MEMORANDUM

Subject: Hydraulic Feasibility of 881 Hillside French Drain

**RESPONSE TO DOE CONCERNS PERTAINING TO THE
PROPOSED OU1 INTERIM REMEDIAL ACTION**

FIGURE 1

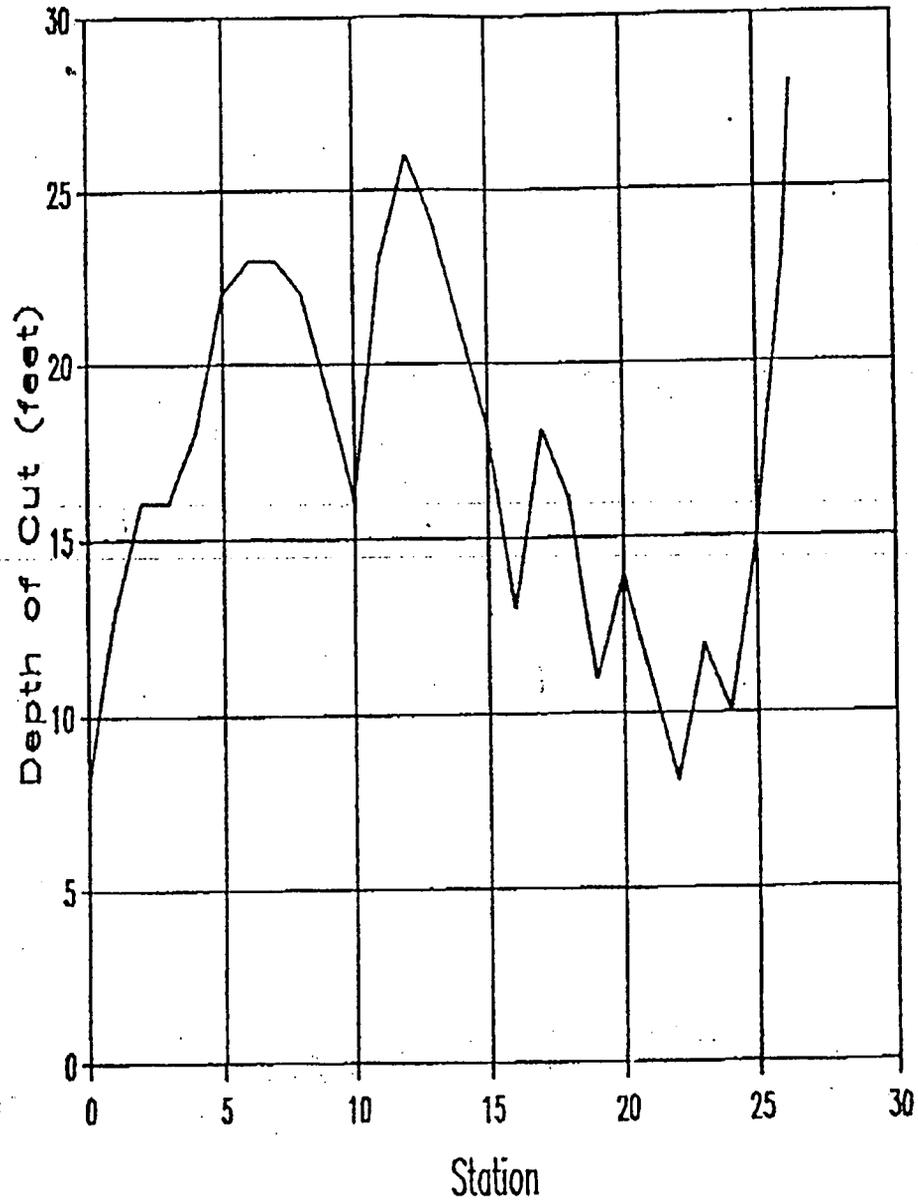
- c. Some of the higher results (e.g., values in excess of 1×10^{-3} cm/s in B 3002 90) may result from accidental hydrofracture of the bedrock during the test.
6. The depth of cut shown on Plate 1 of EG&G (1990) never exceeds thirty feet. Engineering-Science (1991) shows the same alignment except west of the Building 881 footing drain discharge, where the alignment is farther south. The Engineering-Science (1991) cuts are never more than twenty-eight feet (Figure 1).
